Docket Number:	21-BSTD-01
Project Title:	2022 Energy Code Update Rulemaking
TN #:	239076
Document Title:	Statewide Utility Codes and Standards Enhancement Team Comments - Comments on Industry Feedback to Fan Power Budget
Description:	Statewide Utility Codes and Standards Enhancement Team Comments - on Industry Feedback to Fan Power Budget Submeasure of Air Distribution CASE Report
Filer:	System
Organization:	Statewide Utility Codes and Standards Enhancement Team
Submitter Role:	Public
Submission Date:	7/28/2021 6:54:21 PM
Docketed Date:	7/29/2021

**Comments on Industry Feedback to Fan Power Budget
Submeasure of Air Distribution CASE Report**

CALIFORNIA STATEWIDE UTILITY CODES AND STANDARDS TEAM

July 28, 2021

Figure 1: CASE Team Markup of Carrier Graphic Showing Maximum ESP of its Products, Application Requirements, and CASE Assumptions CAV/SZ-VAV Products

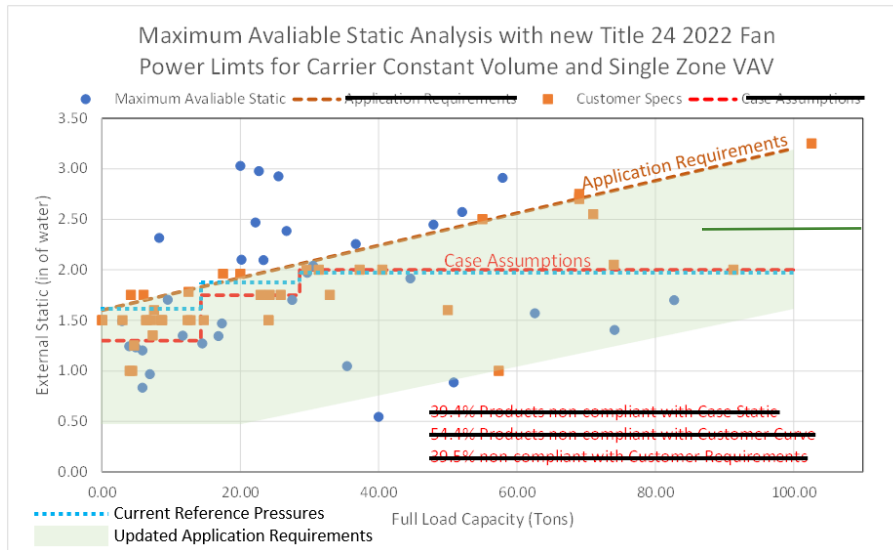
We appreciate the analysis and graphics provided by Carrier. However, we believe that some vital information regarding external static pressures (ESPs) has not been included. Therefore, the Statewide CASE Team has taken the liberty of adding additional clarity to the latest Carrier graphics shared on July 14, 2021. These marked-up graphics for constant air volume/single-zone variable air volume (CAV/SZ-VAV) are shown in Figure 1, and multiple zone variable air volume (MZ-VAV) system types are shown in Figure 2.

First, we believe that the ESP "Application Requirements" cannot be well described with the single orange dotted line. Application requirements are much better represented by a region since there are many potential ESP requirements for any system size. Many applications, such as big box retail and schools, typically have short duct lengths with little pressure drop. Carrier's graphic shows many orange squares below its orange dotted lines. The line should be considered as the upper limit of ESP requirements.

Carrier's suggested upper values for ESP are much higher for CAV and SZ-VAV systems than the reference pressures used to calculate the current fan power limits in

Further, we disagree with showing design ESP requirements (the square orange data points on the graphics) against the new proposed levels. Those design requirements were created by designers not working under the proposed code. Further, we believe that many of these selections are for replacement equipment installed in buildings that may have been designed before fan power limits were in code. The values shown in the graphics representing the CASE assumptions apply to new construction only, and there is a generous additional allowance for replacement equipment that are not included. The primary intent of the Fan Power Budget proposal is to influence designers to create better duct designs. In the CASE Report, we note that the cost justification is based entirely on improved duct design with no change to the equipment fan efficiency or pressure drops.

Regardless of the pressures represented by the orange line, we cannot agree with the description of "non-compliant" for products shown below the line. Those products can be used by the designers at or below the pressures shown. They will not be removed from the market. As we note above, application requirements are a region, not a single line. The Carrier products that fall below the orange dotted line will continue to be available for these lower ESP applications. As a result, the Statewide CASE Team disagrees with the assertion that a given percent of Carrier products will become "non-compliant" from this measure.
